RE: 04E-022
Durakon Industries

Durakon Announces Voluntary Recall for Over Rail Bedliners on Chevrolet Silverado and GMC Sierra Vehicles

PIB #: 200407A

SUBJECT: Chevy Silverado/GMC Sierra Over Rail Installation Notification
******Update******

EXHIBIT 3

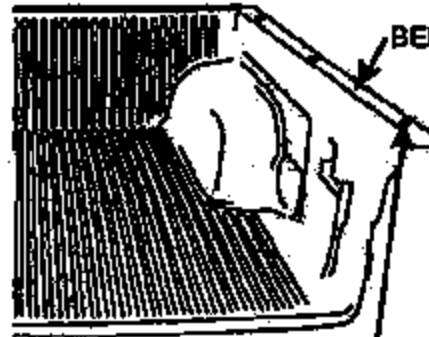
If the bedliner has CamLock side installation on both side walls, no action is required.

If the bedliner has Toggle Lock top installation on the top of both rails, corrective action is required.

If the pickup truck has an AllStar or Patriot overrail bedliner that utilizes a toggle lock top rail fastening system as shown in EXHIBIT 3., the following procedures should be followed:

LABEL PLACEMENT

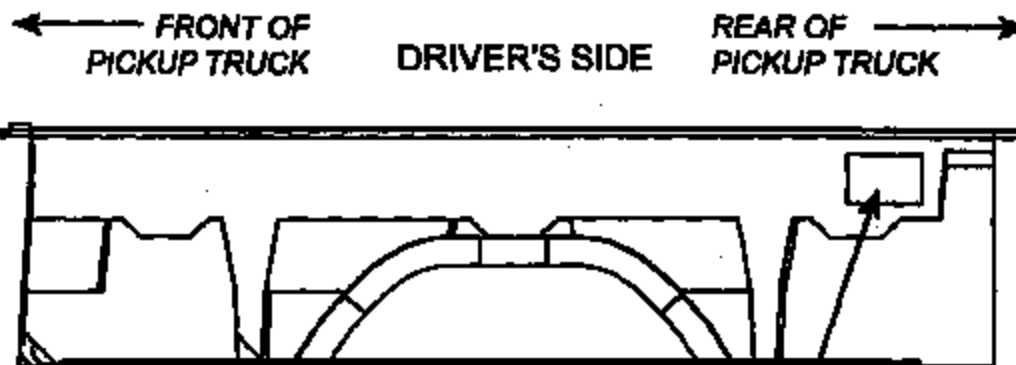
LABEL PLACEMENT IS ON THE OUTSIDE OF THE BEDLINER THAT IS AGAINST THE PICKUP TRUCK SHEET METAL.

EXHIBIT 3

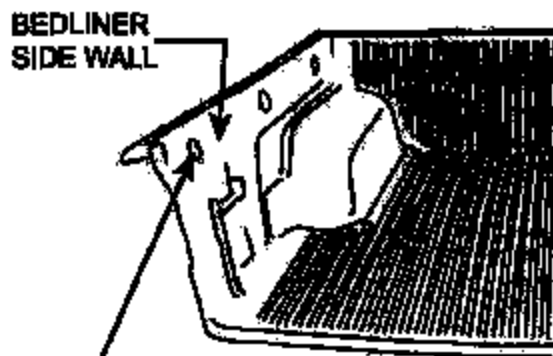
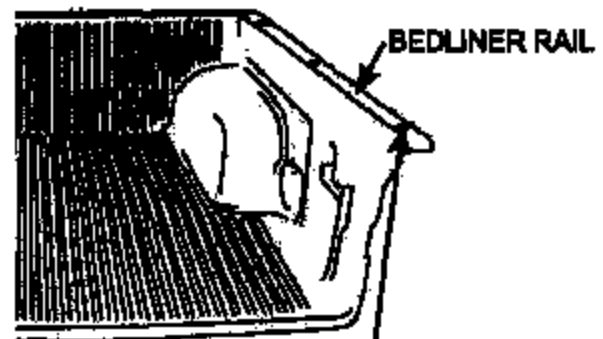
If the bedliner has CamLock side installation on both side walls, no action is required.

If the bedliner has Toggle Lock top installation on the top of both rails, corrective action is required.

If the pickup truck has an AllStar or Patriot overrail bedliner that utilizes a toggle lock top rail fastening system as shown in EXHIBIT 3., the following procedures should be followed:

LABEL PLACEMENT

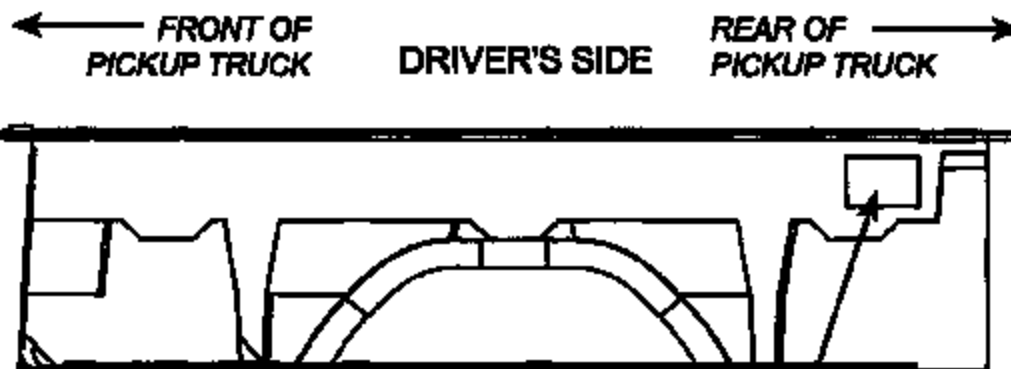
LABEL PLACEMENT IS ON THE OUTSIDE OF THE BEDLINER THAT IS AGAINST THE PICKUP TRUCK SHEET METAL.
